**PCN#20160726001
New Carrier Tape
Information Only**

PCN Number:	20160726001	PCN Date:	07/27/2016
Title:	New Carrier Tape		
Customer Contact:	PCN Manager	Dept:	Quality Services
Change Type:			
<input type="checkbox"/>	Assembly Site	<input type="checkbox"/>	Assembly Process
<input type="checkbox"/>	Design	<input type="checkbox"/>	Electrical Specification
<input type="checkbox"/>	Test Site	<input checked="" type="checkbox"/>	Packing/Shipping/Labeling
<input type="checkbox"/>	Wafer Bump Site	<input type="checkbox"/>	Wafer Bump Material
<input type="checkbox"/>	Wafer Fab Site	<input type="checkbox"/>	Wafer Fab Materials
<input type="checkbox"/>		<input type="checkbox"/>	Part number change
<input type="checkbox"/>		<input type="checkbox"/>	Assembly Materials
<input type="checkbox"/>		<input type="checkbox"/>	Mechanical Specification
<input type="checkbox"/>		<input type="checkbox"/>	Test Process
<input type="checkbox"/>		<input type="checkbox"/>	Wafer Bump Process

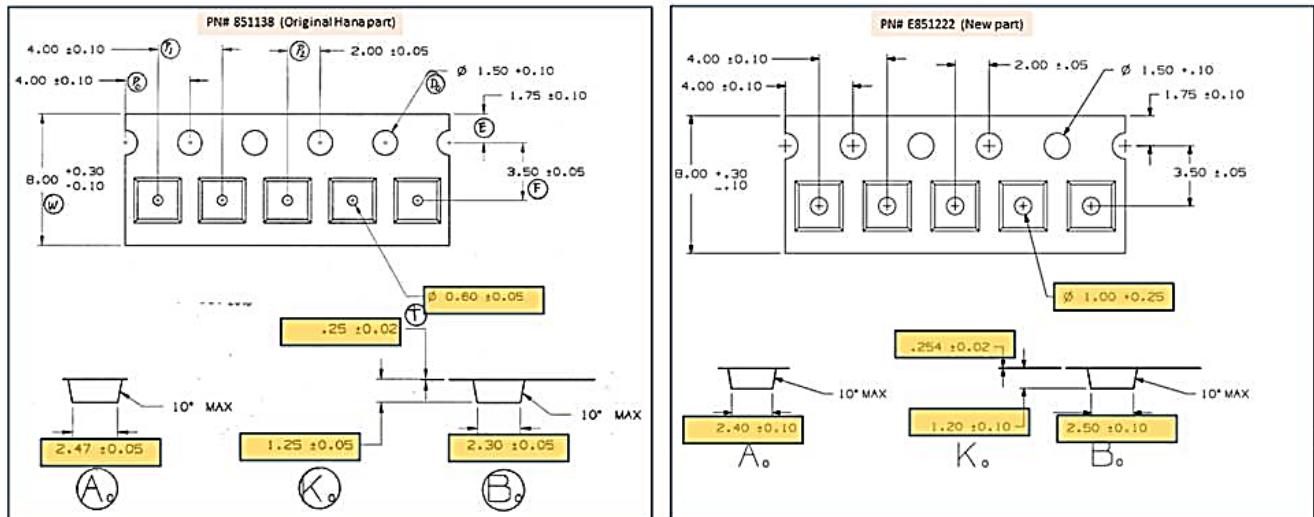
Texas Instruments is pleased to announce the qualification of a new carrier tape for the devices shown below. The material composition between the 2 carrier tapes is the same. A dimensional comparison summary is below:

Dimension	From (851138)	To (851222)
Ao	2.47 (+/- 0.05) mm	2.4 (+/- 0.1) mm
Bo	2.3 (+/- 0.05) mm	2.5 (+/- 0.1) mm
Ko	1.25 (+/- 0.05) mm	1.2 (+/- 0.1) mm
Thickness	0.25 (+/- 0.02) mm	0.254 (+/- 0.02) mm
